HISTORIC AND DESIGN REVIEW COMMISSION

April 05, 2017

HDRC CASE NO: 2017-136
ADDRESS: 1023 HAYS ST
LEGAL DESCRIPTION: NCB 1655 BLK C LOT 15
ZONING: R-5
CITY COUNCIL DIST.: 2
DISTRICT: Dignowity Hill Historic District
APPLICANT: Sarah Edwards
OWNER: Sarah Edwards
TYPE OF WORK: Exterior modifications, fenestration modifications, installation of transom window and side lights

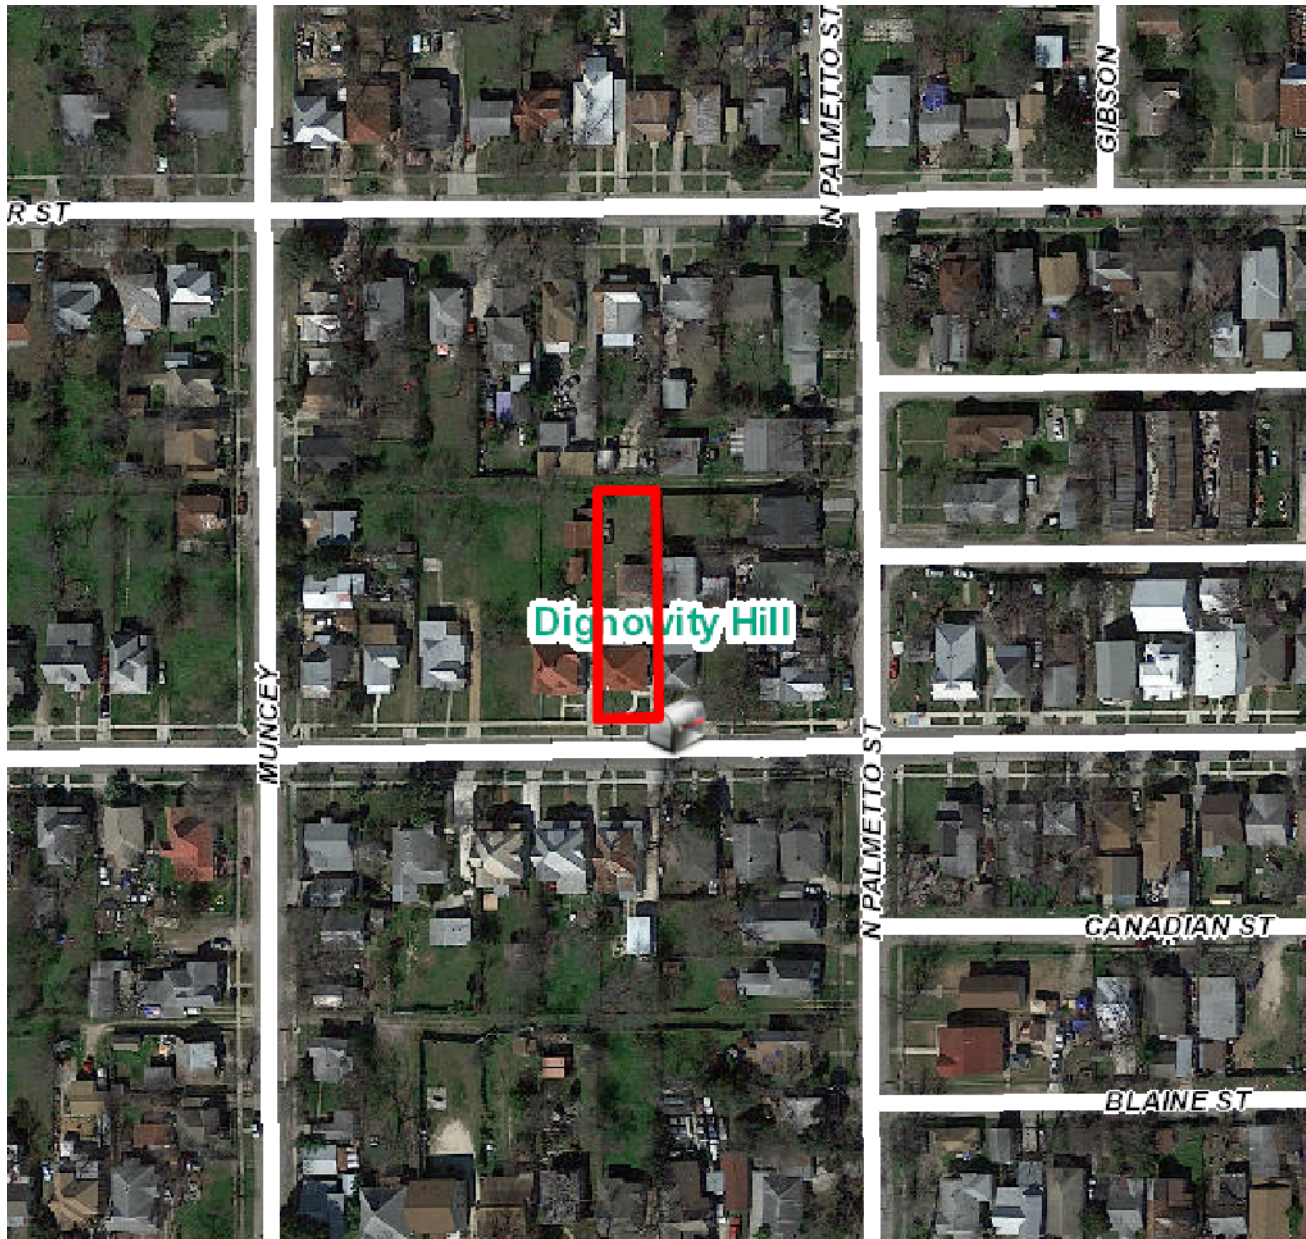
- a. The structure at 1023 Hays was constructed circa 1915 and features traditional architectural elements including a standing seam metal roof, a one story, wrap around porch, a front facing roof dormer and hipped roofs. Between 2011 and 2013, the original front facing door openings was moved from the left side of the front porch to the middle of the porch to be located between the two middle porch columns. Historic window openings and materials were modified from their original profile, the front walkway was modified and the standing seam metal roof was painted red.

- b. At this time, the applicant has proposed to replace the existing front door and sidelights with a front door to feature four window lights, sidelight windows to feature lights half of the height of the door and a transom window to feature five window lights. The Guidelines for Exterior Maintenance and Alterations 6.A.i. notes that historic window and door openings should be preserved. Staff finds that the applicant should return the front door opening to its original location, reopen the original transom window and restore the window opening to its original size that was modified for the current front door based on photo evidence.

Staff does not recommend approval of items #1 and #2. Staff recommends the applicant return the front door opening to its original location, reopen the original transom window and restore the window opening to its original size that was modified for the current front door. Staff finds the proposed door with four window lights appropriate; however, the proposed side lights and proposed transom are inappropriate for the original location.
